Access Compliance Report Public Rights-of-Way (Curb Ramps)

Main Street: LANGFORD_RD		Cross Street: CARLISLE_CT		Location:	E
ADA ID: RPRK211111115731	Ramp Type: Type 4 - Parallel	Initial Pass/Fail: Fail	Overall Compliance: No	Severity Score:	16

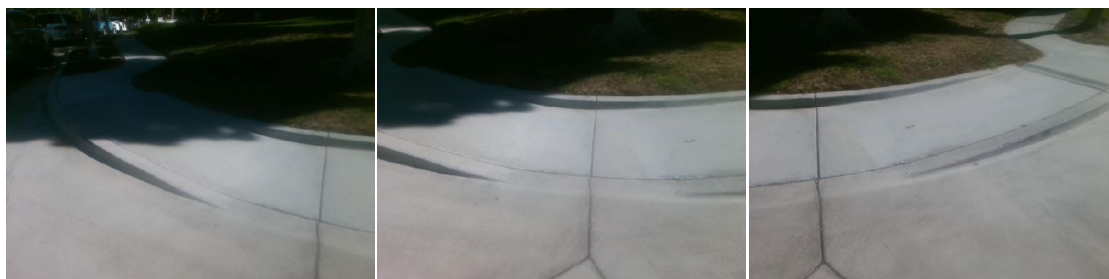
Compliance	Description	Data	Compliance	Description	Data
N/A	Ramp Length LT (in)	138	N/A	Ramp Length RT (in)	141
Yes	Ramp Width LT (in)	53	Yes	Ramp Width RT (in)	53
No	Ramp Run Slope LT (%)	9.7	Yes	Ramp Run Slope RT (%)	4.2
No	Ramp Cross Slope LT (%)	2.5	No	Ramp Cross Slope RT (%)	2.4
N/A	Landing Present	N/A	N/A	DWS Provided	N/A
N/A	Landing Length (in)	N/A	N/A	DWS Contrast	N/A
N/A	Landing Width (in)	N/A	N/A	DWS Length (in)	N/A
N/A	Landing Run Slope (%)	N/A	N/A	DWS Full Width	N/A
N/A	Landing Cross Slope (%)	N/A		DWS Offset Type	N/A
N/A	Landing Movement Obstructed?	N/A	N/A	DWS Offset Left (in)	N/A
	Landing Movement Type	N/A	N/A	DWS Offset Right (in)	N/A
N/A	Landing Shared	N/A			
N/A	Clear Space	Yes			
N/A	Clear Space To Crosswalk (in)	N/A			
N/A	Marked Crosswalk 1	No	N/A	Marked Crosswalk 2	No
	Crossing 1 Direction	NW		Crossing 2 Direction	SW
	Marked Crosswalk 1 Width (in)	N/A		Marked Crosswalk 2 Width (in)	N/A

Remove & Replace Curb Ramp With Two New Directional Ramps or Equivalent.
